UNITED STATES PATENT AND TRADEMARK OFFICE

Office Action Summary	Application No. 10/696,587	Applicant(s) WIRTH ET AL.	
	Examiner PHONG H. NGUYEN	Art Unit 3724

DETAILED ACTION

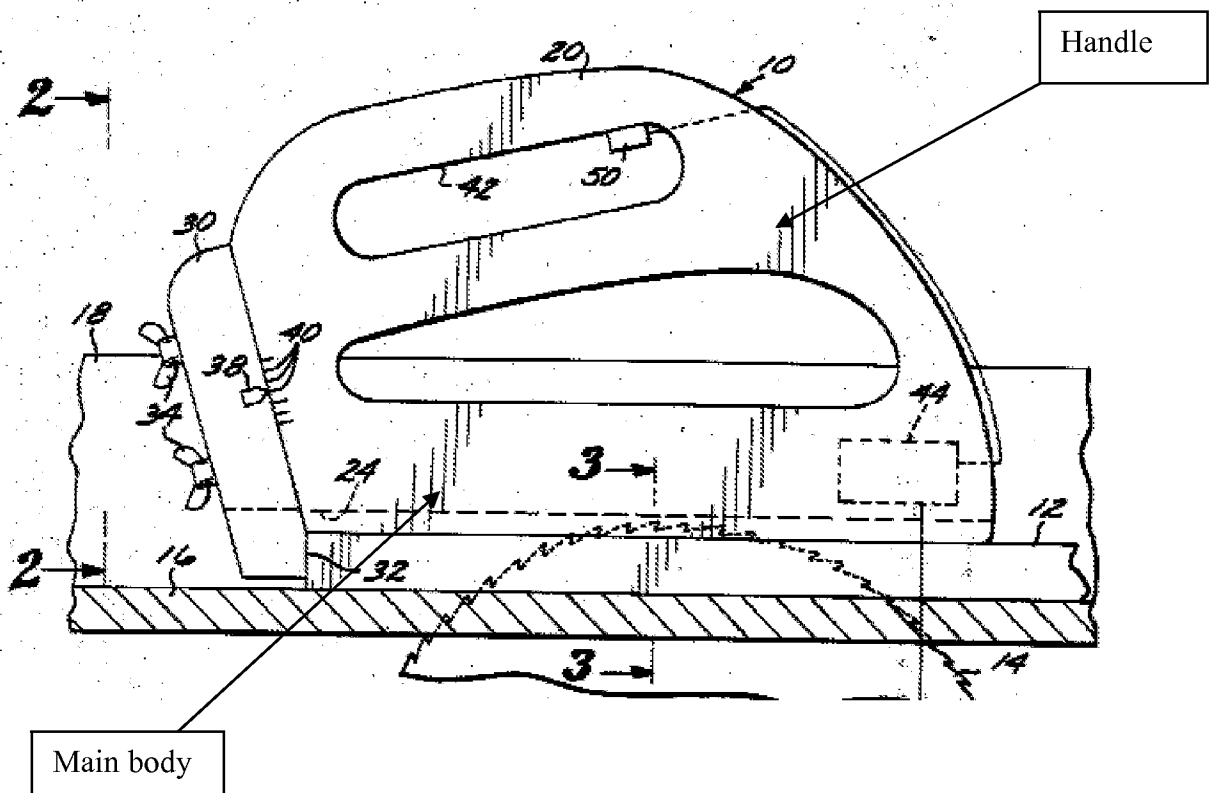
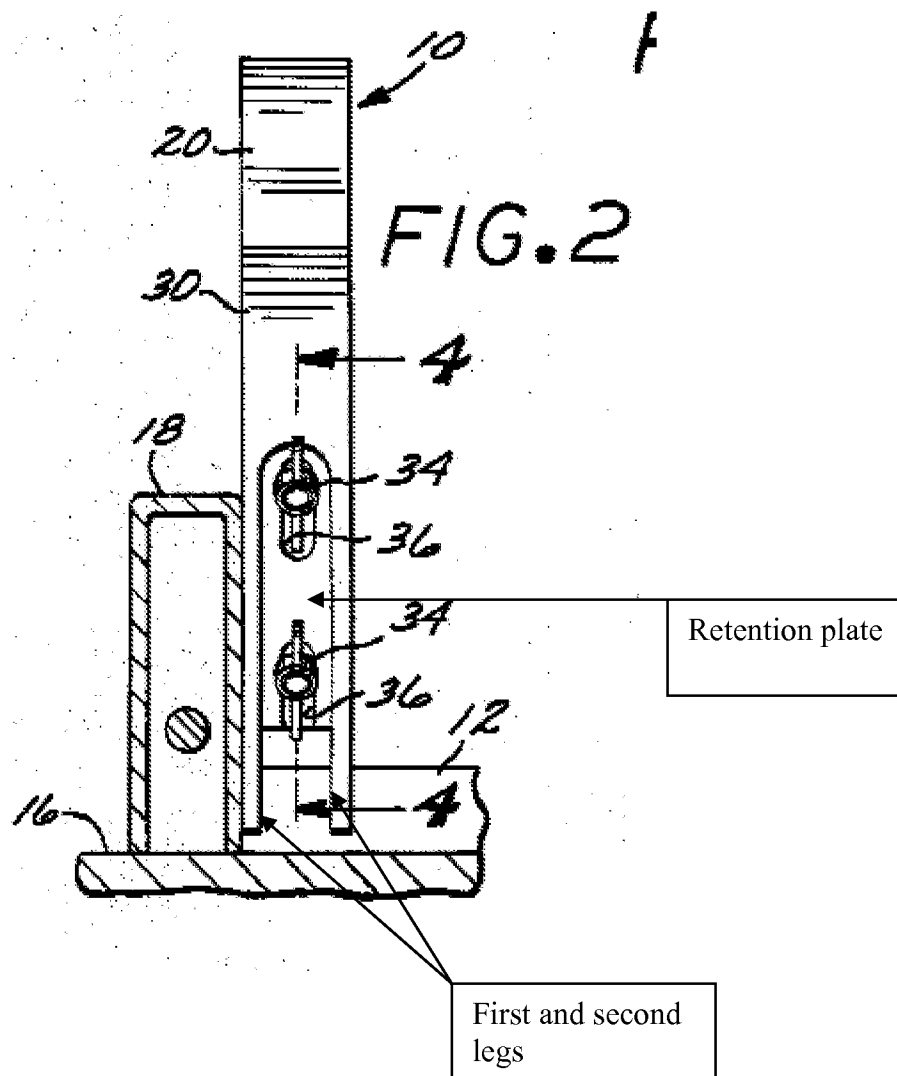
Regarding claim 7, Jennings teaches a push block device comprising:

a main body having a first flat working surface (26, 28) for engaging a top surface of a workpiece;

a handle portion;

a heel component 30 extending from the main body, the heel component 30 having a first, operative position, wherein the heel component 30 projects vertically below the first flat working surface (Fig. 1), the heel component having a second, stored position (the upper and lower wing nuts 34 are removed from their threaded shafts, the heel component could be removed and repositioned 180 degrees with respect to the body portion 20 such that the lower portion 32 of the heel component faced straight up. One could then reinstall and tighten the upper wing nut 34.), the heel component 30 defining a second working surface 32 and first and second legs.

Regarding claim 8, the first and second legs being secured to the main body is best seen in Fig. 1.

Regarding claim 11, Jennings teaches a push block device comprising a main body, a handle component, a heel component as explained in claim 7 above, and the heel component further having a retention plate as shown in Fig. 2 above.

Regarding claims 17 and 18, Jennings teaches a push block device comprising a main body, a handle component, a heel component as explained in claim 7 above, and the handle having a grip portion and a leg portion (Fig. 1).
